MEADOWBANK TAFE – MULTI STOREY CAR PARK EXTENSION L3 & 4

CONCEPT REPORT

BUILDING CODE OF AUSTRALIA VOL 1 2019 AMENDMENT 1

Report prepared for	Hansen & Yuncken Sydney Corporate Park Building 1, L3, 75-85 O’Riordan Street Alexandria NSW 2015 Attention: Sasha Vuckovic
Report prepared by	Metro Building Consultancy Suite 102, 12 Mount Street North Sydney NSW 2060 Consultant: Sean Moore
Report reference	19209-MSCP EXT R01
Job number	19209
Date	04 th October 2021

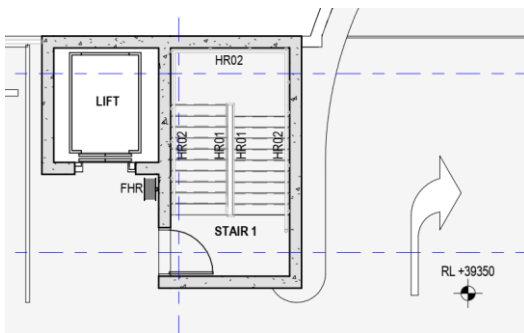
Shafts required to have an FRL must be enclosed at the top and bottom by construction having an FRL not less than that required for the walls of a non-loadbearing shaft in the same building, except that these provisions need not apply to:

- the top of a shaft extending beyond the roof covering, other than one enclosing a fire-isolated stairway or ramp; or
- the bottom of a shaft if it is non-combustible and laid directly on the ground

This applies to fire stair shafts, lift shaft and any services shafts eg mechanical services shafts, they must be enclosed at the top with the same FRL as the walls of the shaft or extend above the roof.

The developed design drawings are required to include details of the FRL of the top of the two fire stair shafts and the lift shaft.

8.7.4 Fire rating of pipework supports

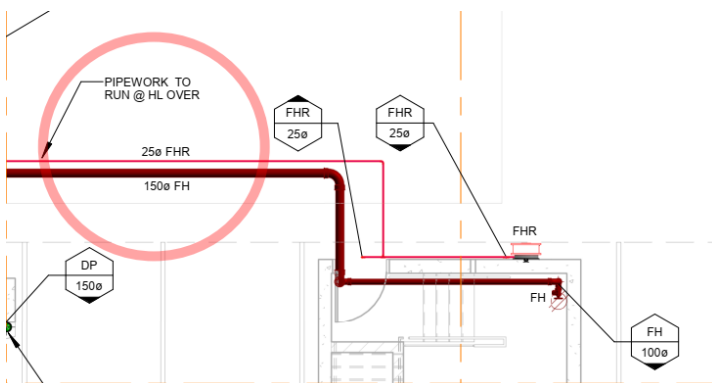
The hydraulic services drawings are required to include details of how the internal fire hydrant pipework support comply with clause 8.7.4 of AS2419.1 2005 below. As the building is not provided with sprinklers this clause applies and the pipework is required to be protected. Please refer to the product in the following link as an example of suitable protection <https://www.progressivematerials.com.au/product/protect-a-pipe/>.

Where pipework is likely to be exposed to fire in a building that is not protected by sprinklers, then the pipe supports shall have a FRL not less than 60/-/-, while maintaining a pipe-support temperature of not less than 500°C when tested in accordance with AS 1530.4; or other measures shall be taken to prevent its early collapse when exposed to fire.
